RE: NICHOLS PROP

RE: Nichols Property Sketch Plan

NICHOLS PROPERTY
TAX MAPS 28 & 34 PARCEL 1
8th Election District
Howard County, Maryland

SKETCH PLAN

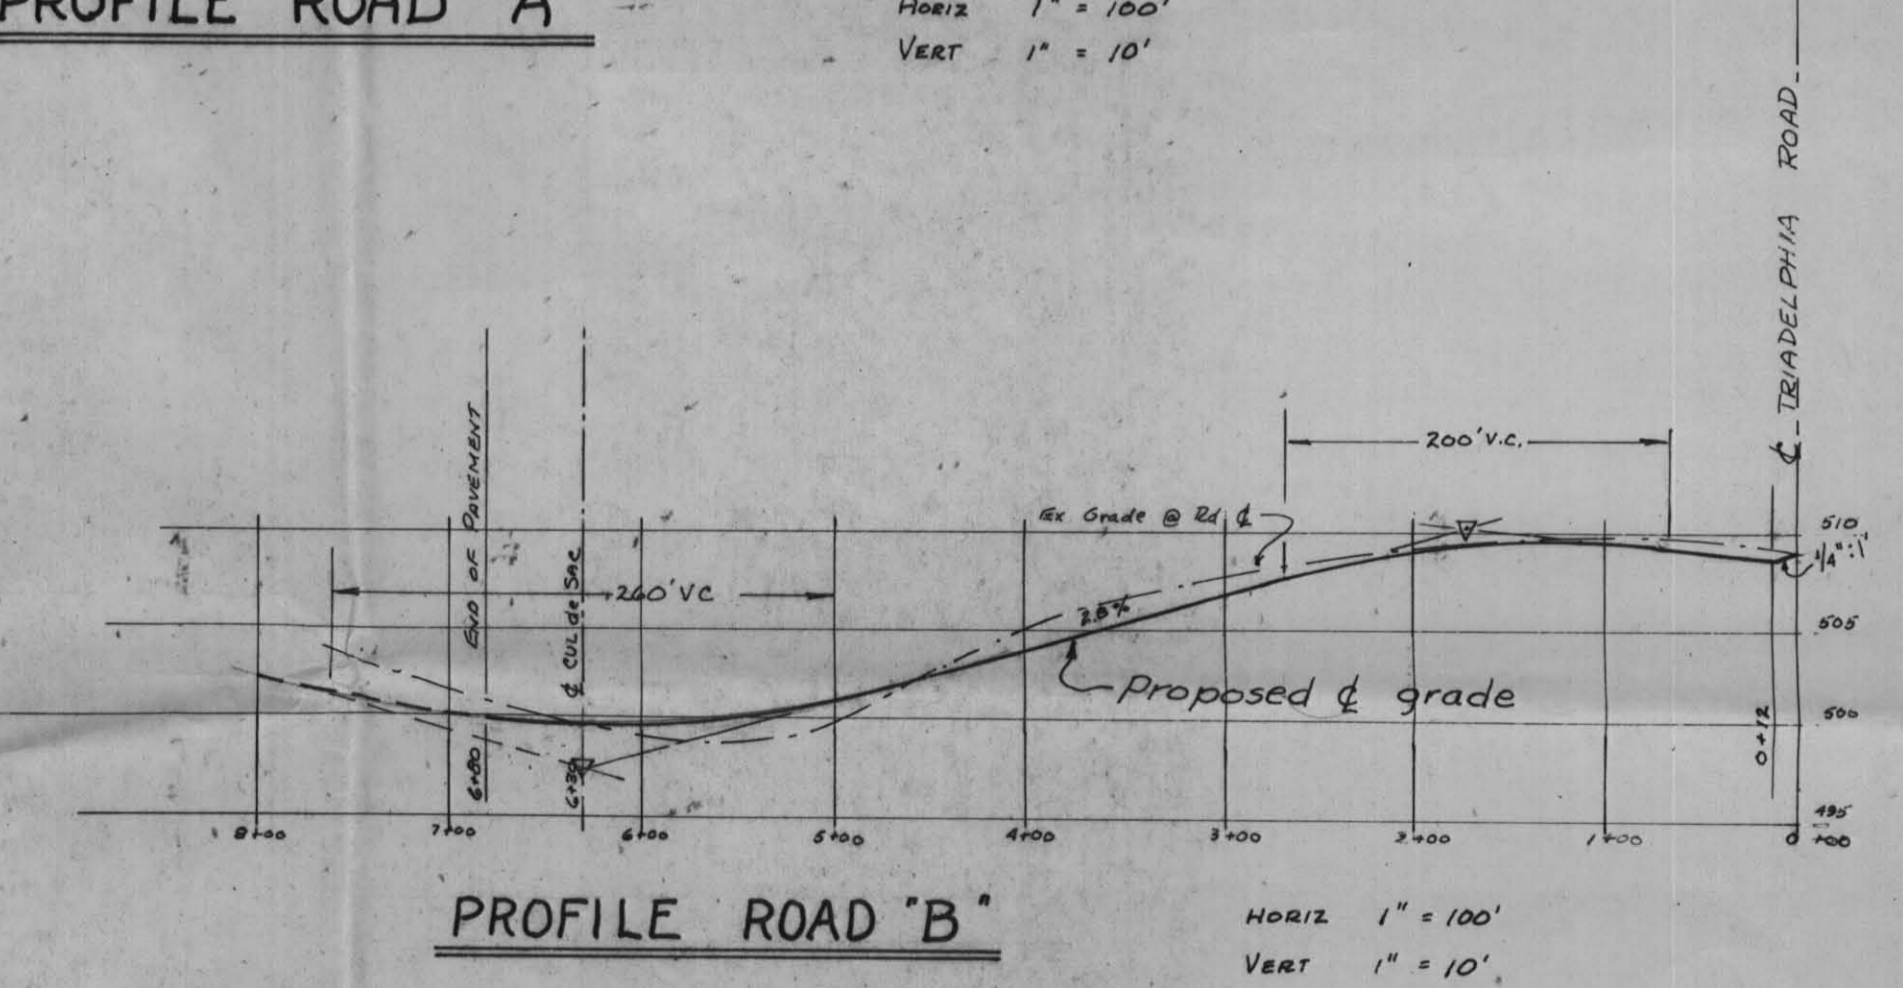
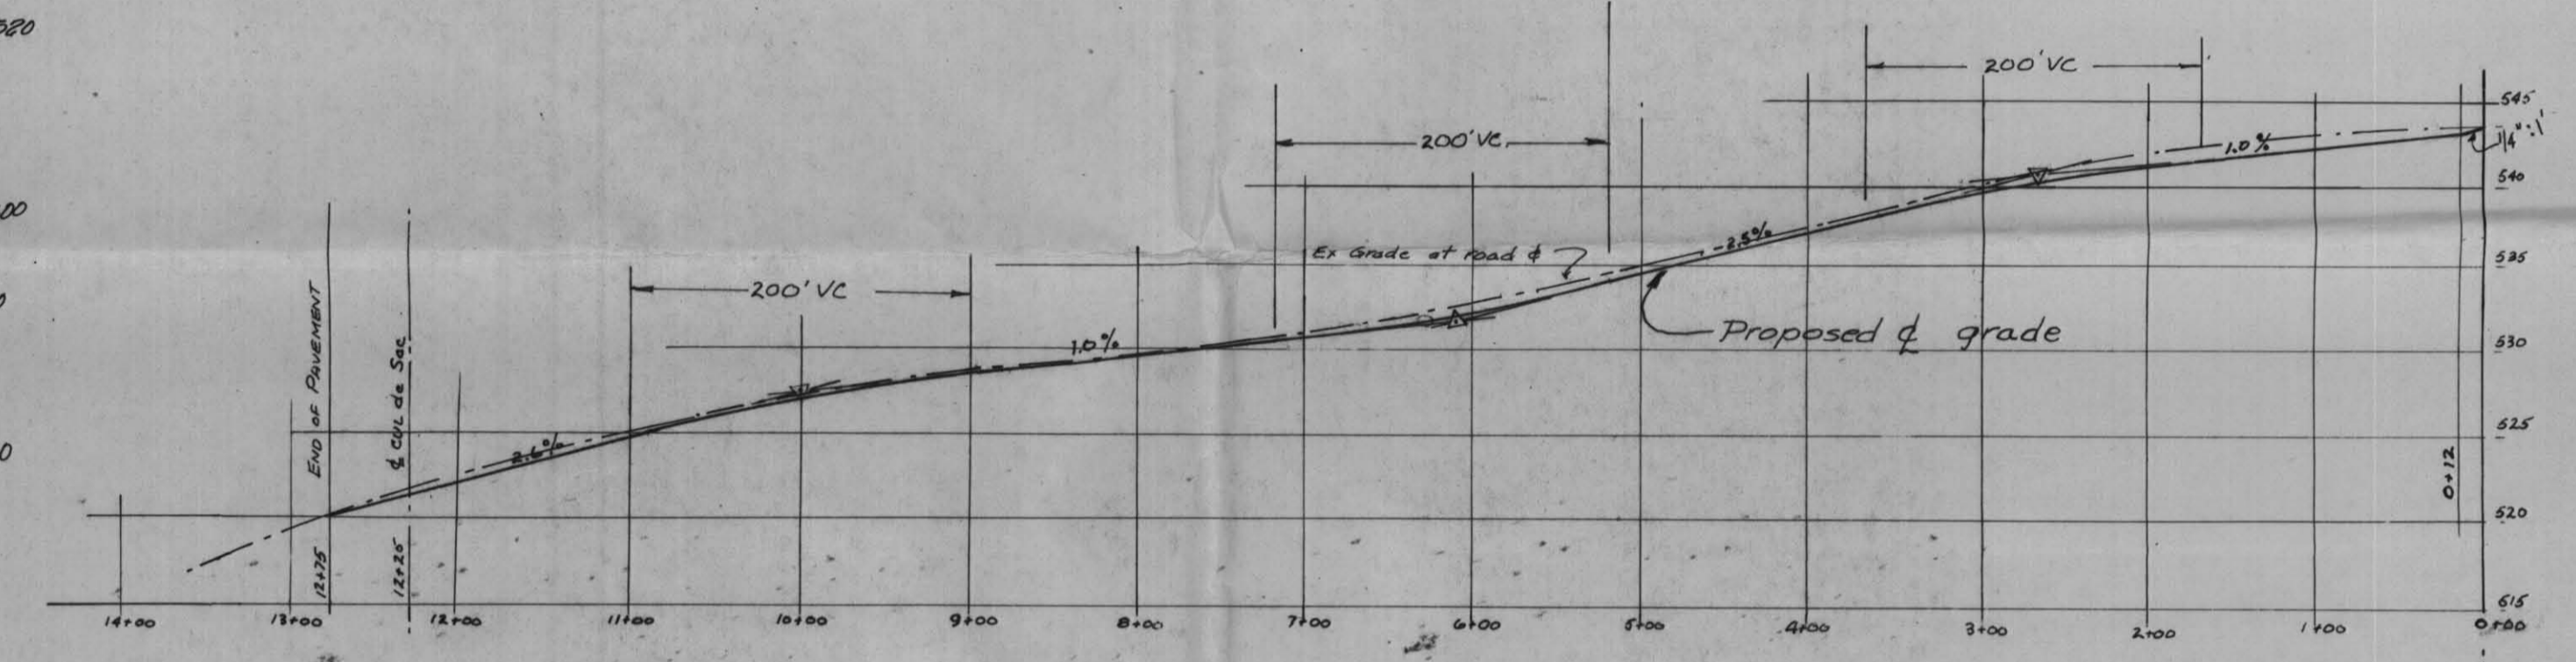
OTHER COMMENTS: Prior to our review & comments a sketch plan with 2 foot contours is required; no percolation test application can be accepted without it.
